Notice of Reserve Trust Manager Meeting

4.1 Captain Cook Memorial Park Master Plan

Captain Cook Memorial Park, Ballina

Captain Cook Memorial Park – Draft Master Plan SUBMISSIONS REPORT

OPTION 2 NEW ONE-WAY EASTBOUND FROM RIVER STREET

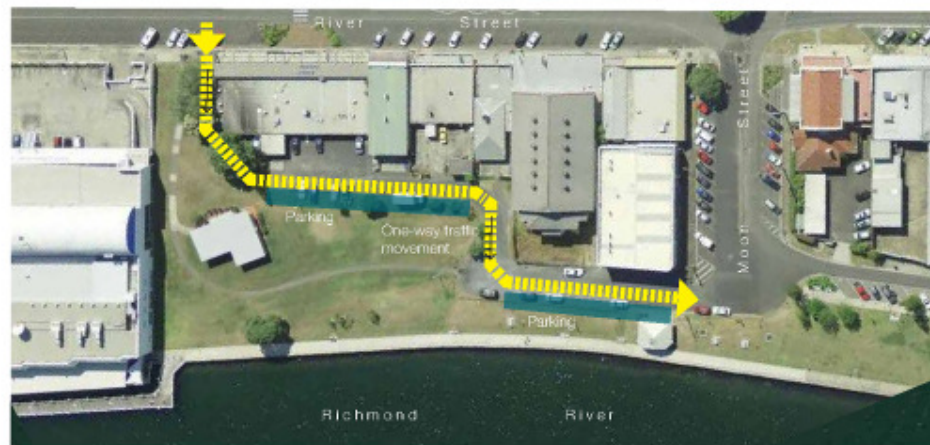
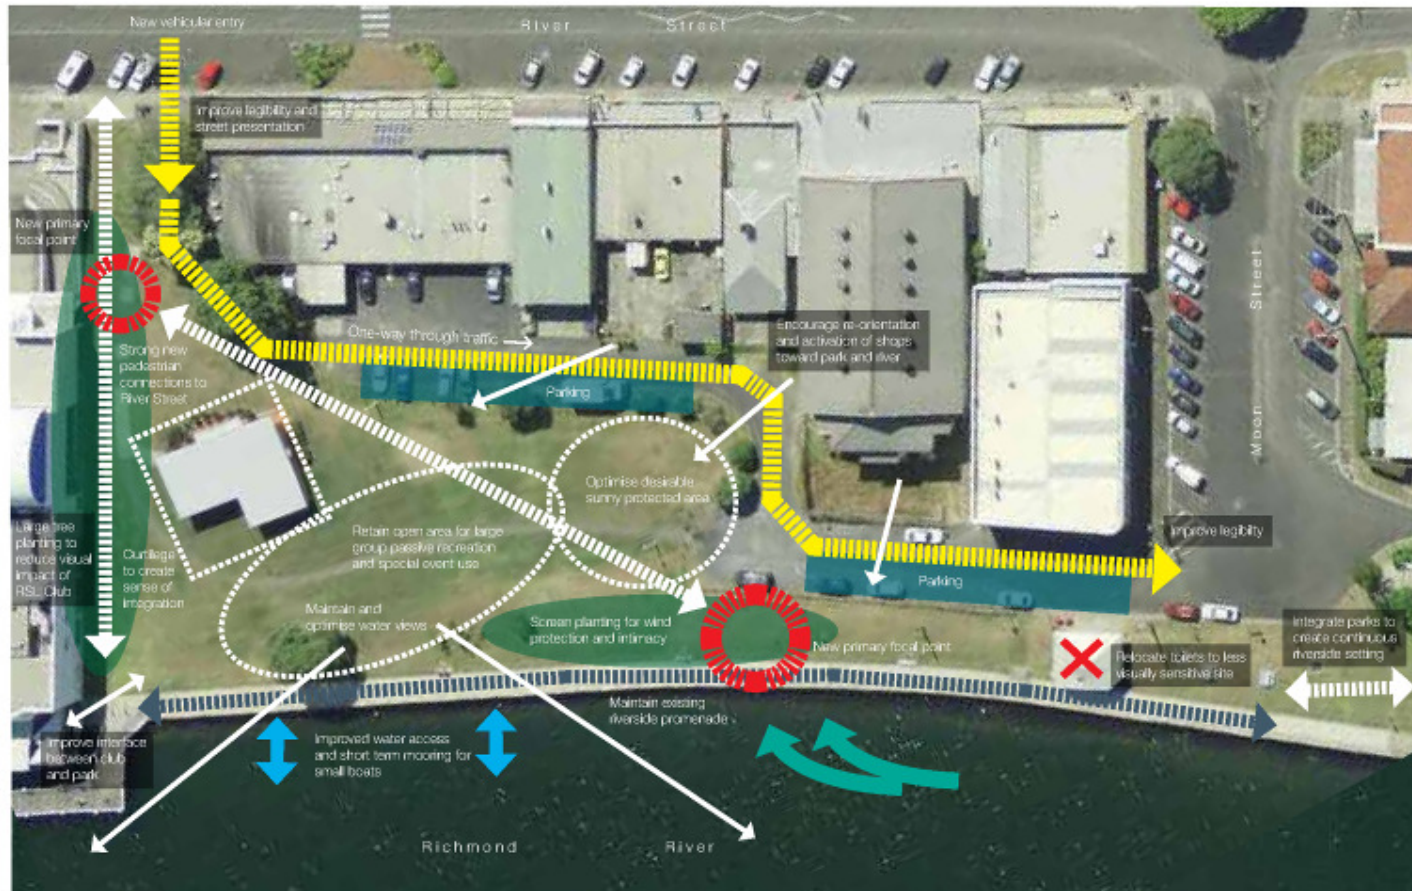
2. Traffic Movement (Page 2 OF Masterplan) – concerns relating to Option 2:
 - Potential pedestrian conflict plus need to take into account elderly persons on scooters going to Club as the proposed road crossover is adjacent to the club car park entry,

2. There are pedestrian/scooter & car access security concerns with the new road cross over – Option 2, not considered.
3. You will need to identify if there are any utility services outside the Clubs eastern boundary where the large tree plantings are proposed; i.e. sewer, stormwater, electrical, water supply & phone lines. Council should have records of all drainage & water supply utilities.

<i>Proposed one way road gives hoons access to do circuits late at night when no surveillance is available</i>	One way laneway is the preferred approach to reserve access. The proposed access provides for greater parking space, minimises impact

CWA HALL

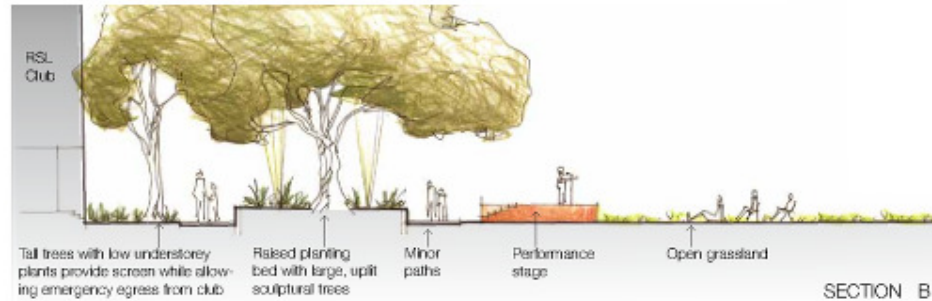
Page 10. C.W.A. Hall. What happens if we don't want to have glass doors opening onto an open patio that's added to our rooms? Years ago we also had to add security grills to all of our windows because of vandalism to our rooms ,grills will have to be added to the glass doors because of security reasons, if this plan goes ahead. *Who will pay for all of this ?*

LANEWAY DESIGN

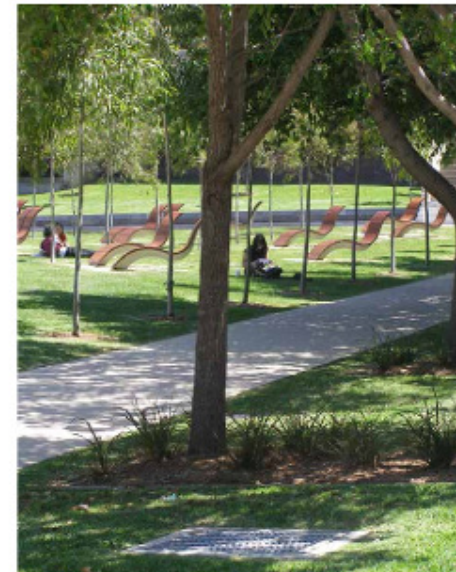
Summary of Submission	Staff Response
<i>Parking: CWA currently have six parking spaces allocated by council would this still be allocated under the new plan. One way street option would limit number of parking spaces.</i>	Provision of parking for the CWA would be considered during the design of the road.
<i>New outdoor setting: Does this mean the CWA rooms would be available to the public to use?</i> <i>Additions may encourage use by adolescents and adults, drinkers and homeless.</i> <i>Vandalism concerns.</i> <i>Cost and maintenance of new additions.</i>	Whilst the CWA is licensee of the building it will determine the availability of the hall to the public and the frequency of its use. This may occur occasionally but could be limited through building design elements. Noted. Again could be addressed through building design elements. Whilst Captain Cook Memorial Park does not include the land parcel occupied by the CWA, opportunities associated with the CWA Hall’s presence on the land and its relationship with the park area have been examined through the master planning process. Additions to the CWA hall have been identified in the master plan to integrate the facility into the park and highlight potential opportunities. Any additions to the building would be at the discretion of the licensee of building and Crown Lands. The maintenance of landscaping elements encroaching into the licensed area would be addressed as part of the detailed design and implementation of the master plan elements.

1. At the present time C.W.A. Ballina Branch have been allotted six parking spots in front of the rooms by Council., would these still be allocated in your plans for a garden & park (Page 8). If you go ahead with the one way traffic plan from River Street, this certainly would limit parking spaces.
